ARCHITECTURAL REVIEW BOARD STAFF REPORT

Project #/Name	ARB-2025-05: Northside Drive Industrial Initial
Review Type	Initial Site Development Plan and Second Review of Architecture
Parcel Identification	03200-00-00-022M0, 03200-00-00-02200 (partial)
Location	Southwest corner of Seminole Trail (Route 29) and Northside Drive (Figure 1)
Zoned	Heavy Industrial (HI), Entrance Corridor (EC), Airport Impact Area (AIA)
Owner/Applicant	Northside Drive LLC / Southern Development (Kevin Lancaster)
Magisterial District	Rio
Proposal	To construct a 72,000-sf warehouse in addition to associated site improvements.
Context	The site is part of an industrial-zoned area that extends to the north, west, and southwest. Residential developments are located to the south and across Rt. 29 to the east.
Visibility	The upper portions of the building’s north, east, and south elevations will be readily visible from the Route 29 Entrance Corridor.
ARB Meeting Date	May 5, 2025

Figure 2: Original Design December 2, 2024.

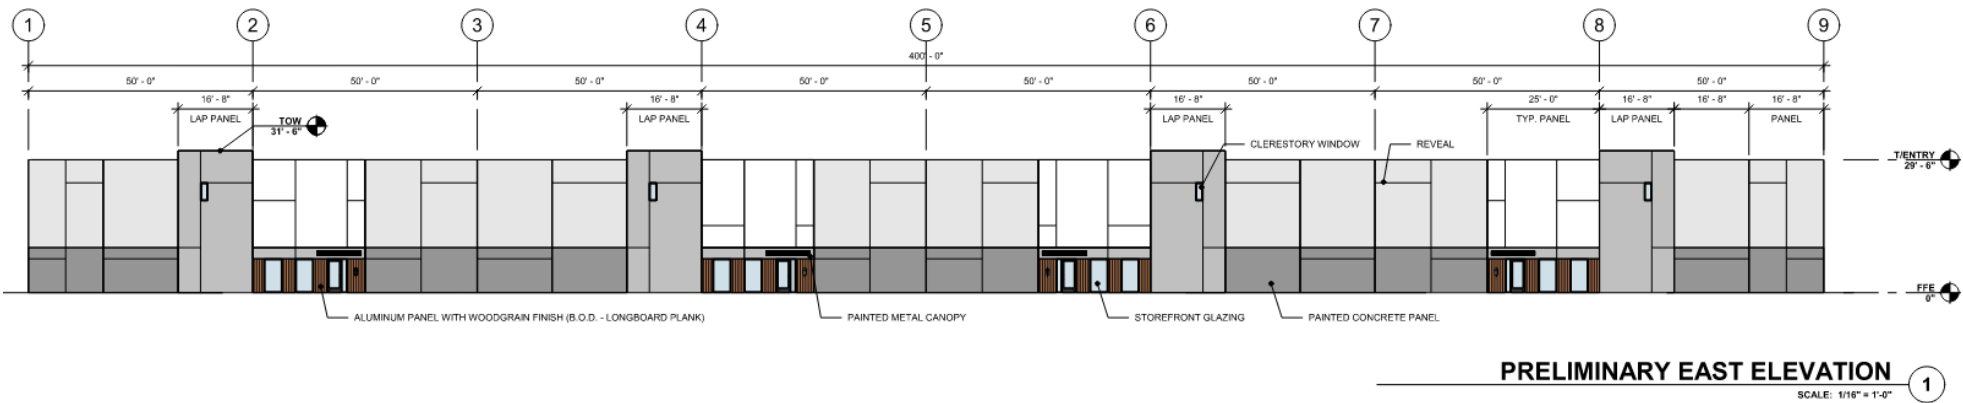
Since the previous review, the design of the elevations visible from the entrance corridor has been revised. The original forms and details have mostly been eliminated and replaced with variations in paint color and scoring lines at different heights. Additionally, the tower-like structures that indicated the entrances have been repositioned, and the corner elements have been completely removed (Figures 2 and 3).

1. Revise the building design to provide detailing that better reduces the building's scale.
2. Revise the building design to use earth tone paint colors.

3. Revise the building design to provide additional treatment at the northeast and southeast corners of the building.
4. Revise the building design to provide greater variation in parapet heights.
